DEVELOPMENT REVIEW COMMITTEE (DRC) COMMENT REPORT

PROJECT NAME: Suncrest Court – Block 3

CASE NUMBER: R18028

REQUEST: Site Plan Level II Review: 20 Multifamily Residential Units

- d. **Existing Stormwater Asset Map possibly affected by the Proposed Development:**

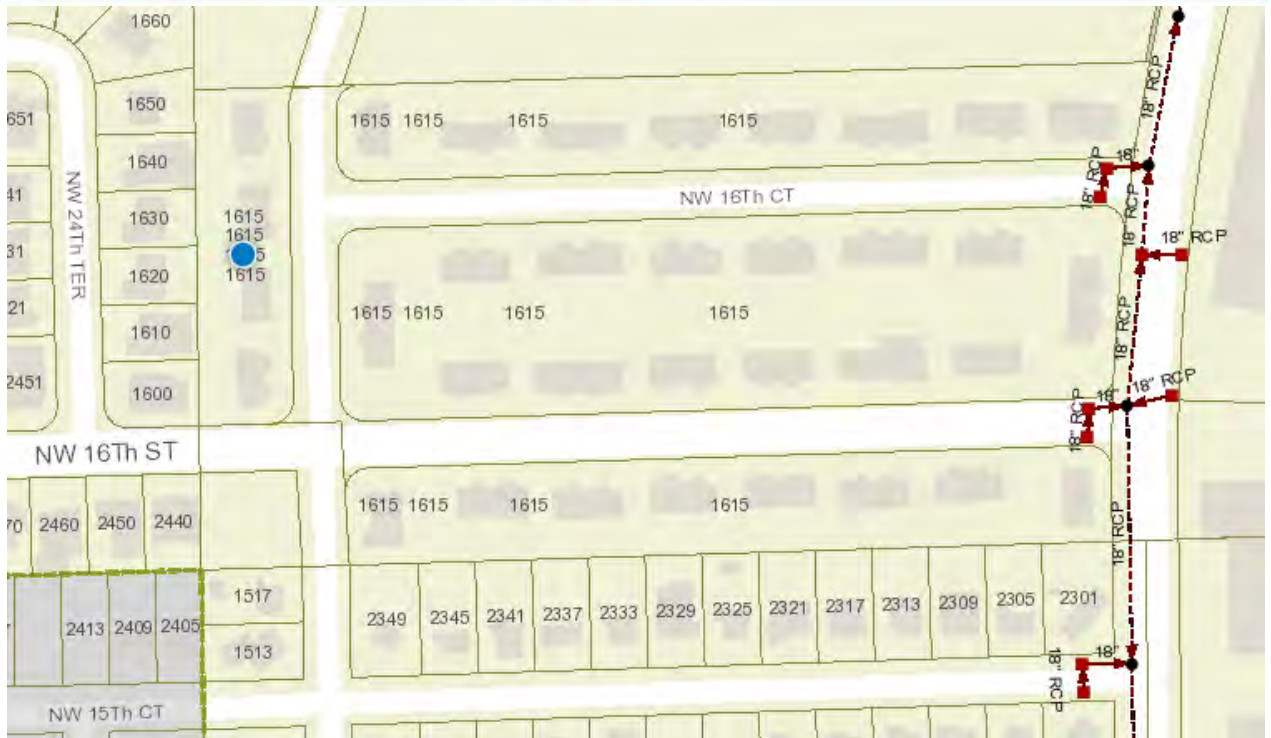
14. The City owns and maintains stormwater infrastructure adjacent to the proposed development as shown with green line work in the map provided at the end of this report. The following comments pertain to possible impacts of the proposed development and/or construction activities to the existing condition of the City's stormwater assets. The applicant shall provide an itemized response letter addressing the following comments:

- a. Please note that no private stormwater infrastructure (drainage pipes, wells, or basins,) can be constructed in City Right of Way or in City drainage easements. Please remove any proposed stormwater systems that are not in compliance with this requirement or provide appropriate documentation of City Rights-of-Way or easement vacated to allow the construction of private underground utilities.

- b. If the development is proposing to remove street swales and construct parallel parking and concrete curbs as shown on the overall site layout, the Civil engineer shall address the City street flood protection criteria & maintenance of City's stormwater assets. Please coordinate requirements with Engineering.
